REPORT OF STRUCTURAL STEEL INSPECTION

PROJECT: Ocean Gateway Garage
Portland, ME

REPORT #: 07-SIS-117-050

TYPICAL DETAIL DT TO DT CONNECTION NEAR LINE A-2
OCCURS TWO LOCATIONS EACH LEVEL

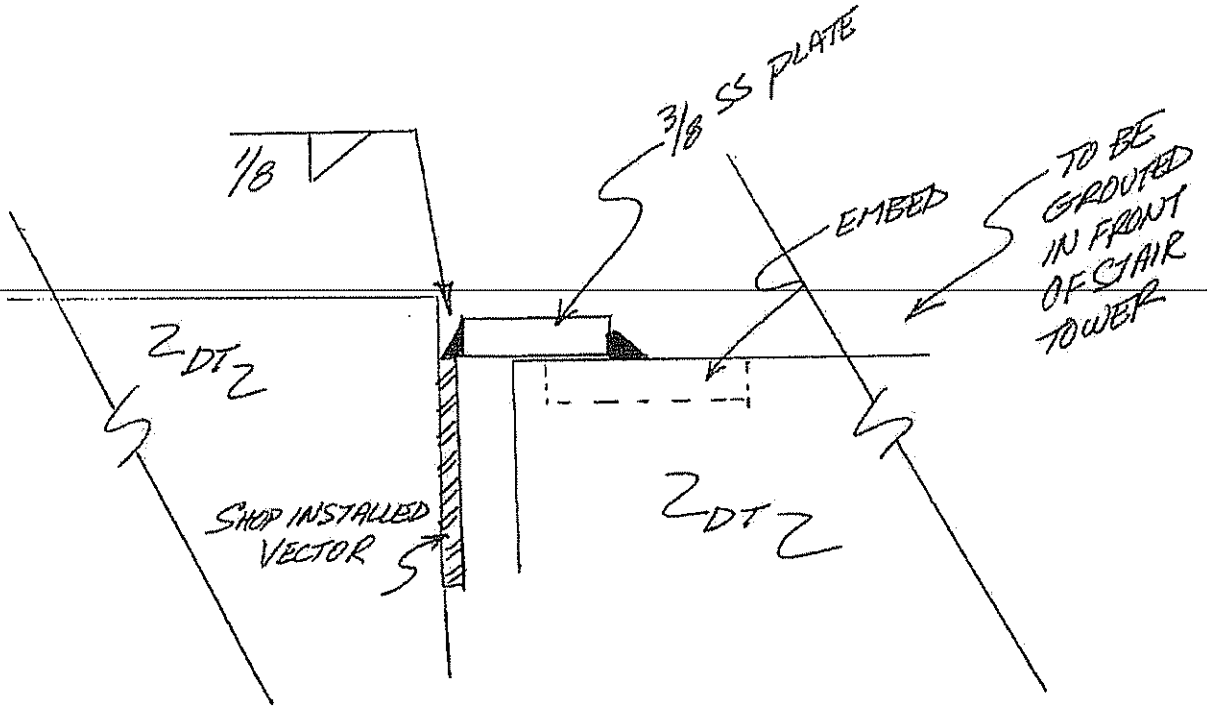
- Vector not welded near D1.9
- At recessed area near stair line A.2 vectors were shop installed at wrong elevation. I don't know if the corrective work is acceptable. I will submit a sketch with my report for the engineer to review. This occurs at all levels.
- Cut out and repair moment connection as marked at E2.1 bottom flange.
- Add 5/16 reinf. fillet at F2.1
- Misaligned vectors near A.5/2.1
